INDESIT company

Model type:
AVSD107EX

Commercial code:
F029702

n1040325: New shock absorber fixing system with pin

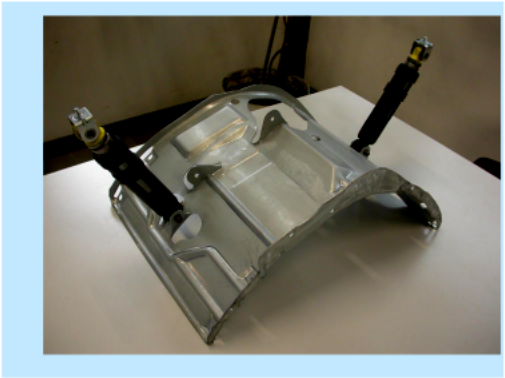
From serial no. 40427.0001, shock absorbers have been fixed to the tank unit cradle with two 11 mm pins code C00110163 (see fig. 01 and 02 enclosed) in place of the 8 mm screws code 093750 and relevant locking nuts code 030443, on all washing

machines and dryers produced in the Comunanza factory.
The items affected by this modification are:
1) The cradles have the same Service code, as they can be used in place of the new ones after widening the shock absorber fixing holes to a diameter of 10 mm.
Code 093848 - Tank unit cradle 46 lt
Code 093878 - Tank unit cradle 40 lt.
2) The new shock absorbers, with fixing bushing having no s/steel spacer, are not managed as they are interchangeable with the premodified items (make sure they are CIMA type, as the managed items), fixed with M8 screws code 093750 and related locking nut code 030443 (see figs. 05 and 06).
Code 093884 - Shock absorber 80 N
Code 093885 - Shock absorber 100 N

To remove the shock absorber from the tank, first extract the pin with a few hammer taps (see fig.03) until it is aligned with the tank bracket and then pull it out with a pair of pliers (see fig. 04).
(To refit the shock absorber use a new pin. Insert the pin until the toroidal edge is aligned with the bracket.)

n1040326: Two-bearing mechanism on Slim range washing machines

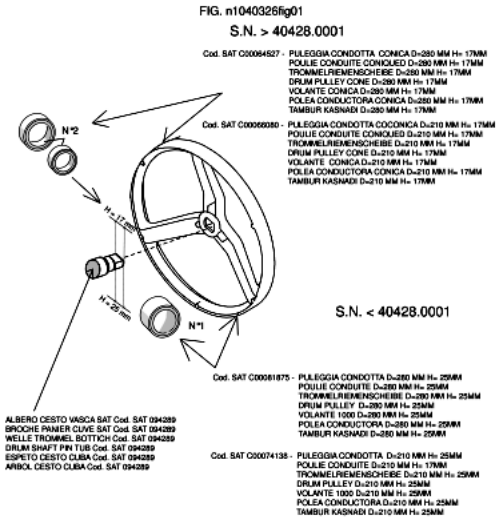
From serial no. 40428.0001, all Slim range models produced in the Comunanza factory have been equipped with a two-bearing mechanism in place of the single-bearing one.

The Service codes of the new mechanism are:
Service code C00096186 - SEAL RING CV4;
Service code C00002591 - BEARING 20X47X14 6204 SKF;
Service code C00013563 - BEARING 25 X52 X 15 6205 - 2Z SKF;
Service code C00110340 - CROSS WITH SEAL RING (2C) SNELLA;
Service code C00094289 - EVO 40L TANK SLIM (1-C) > (2-C)EVOII;
Service code C00094290 - OUTER- SET 40 L.(1-C)>(2-C)EVOII;
Service code C00064527 - DRIVEN PULLEY CONE D=280 MM H= 17MM;
Service code C00066080 - DRIVEN PULLEY CONE D= 210 MM H=17 MM.

The tank assembly with the new two-bearing cross has the same Service code as the single-bearing one (C00094289); the latter will be available until stocks run out.
When replacing the tank, make sure that the value H (17 mm or 25 mm) of the basket cross shaft corresponds to the value H of the pulley (see Fig.001).

The following premodified items will continue to be used:
Service code C00026298 - BEARING BA2B 633667 30X60.03X37;
Service code C00039667 - SEAL RING;
Service code C00074137 - CROSS WITH SEAL RING;
Service code C00081875 - DRIVEN PULLEY D=280MM H=25MM;
Service code C00074138 - DRIVEN PULLEY D = 210MM H=25MM;
Service code C00026299 - SEEGER RING SB 60X1,5.

Fig . 001

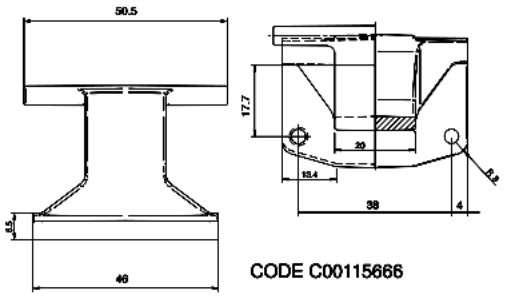
From serial no. 50207.0001, all Ariston models produced in the Comunanza factory (see table 001 attached) with industrial code (given on the rating plate) starting with 80, have been equipped with a Zamac hinge with 150° opening angle, code C00115666 (see Fig.001).
This modification has involved the introduction of the following items:

Code C00115670 - Complete door EVOII 150° white 27 with standard glass;
Code C00115674 - Complete door EVOII 150° white 27 with long glass;
Code C00115668 - Complete door EVOII 150° silver with standard glass;
Code C00115673 - Complete door EVOII 150° silver snella standard glass;
Code C00115662 - EVOII body for 150° hinge white 27
Code C00115663 - EVOII body for 150° hinge silver 27
Code C00115664 - Snella EVOII body for 150° hinge white 27
Code C00115665 - Snella EVOII body for 150° hinge silver

The premodified items are not interchangeable separately with the modified ones.

Code C00096416 - Complete door EVOII LB 180° standard depth silver;
Code C00097374 - Complete door EVOII 180° WD 180° white 27 long glass;
Code C00110133 - Complete door EVOII Standard 180° white 27
Code C00110178 - Complete door EVOII Snella 180° Silver;
Code C00091836 - EVOII body white 27 for 180° hinge;
Code C00094306 - EVOII body silver for 180° hinge;
Code C00094305 - Snella EVOII body white 27 for 180° hinge;
Code C00094307 - Snella EVOII body silver for 180° hinge;

Fig . 001

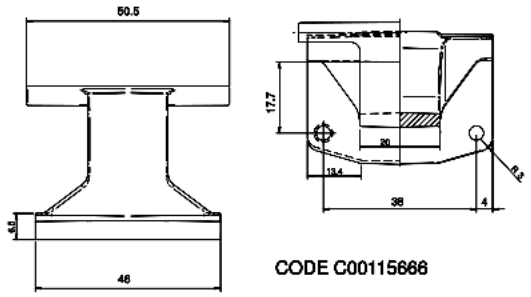
From serial no. 50315.0001, the new "Polar White" colour is used on all washing machines and washer-dryers produced in factory 80 in place of White 27.
The third last number of the Industrial Code given on the rating plate of the modified models is 9 (e.g. 80286390900).

To determine the new Polar White codes, it is necessary to know the industrial code or serial number of the appliance being repaired.
The new items, which bear the initials "PW" in place of "B27", are not aesthetically interchangeable with premodification items as the whites are different. Both colours will be available for some time.
The items affected by this modification are:
Body, rear panel, top, control panel, handles, buttons, knobs, knob disc, door and plinth.
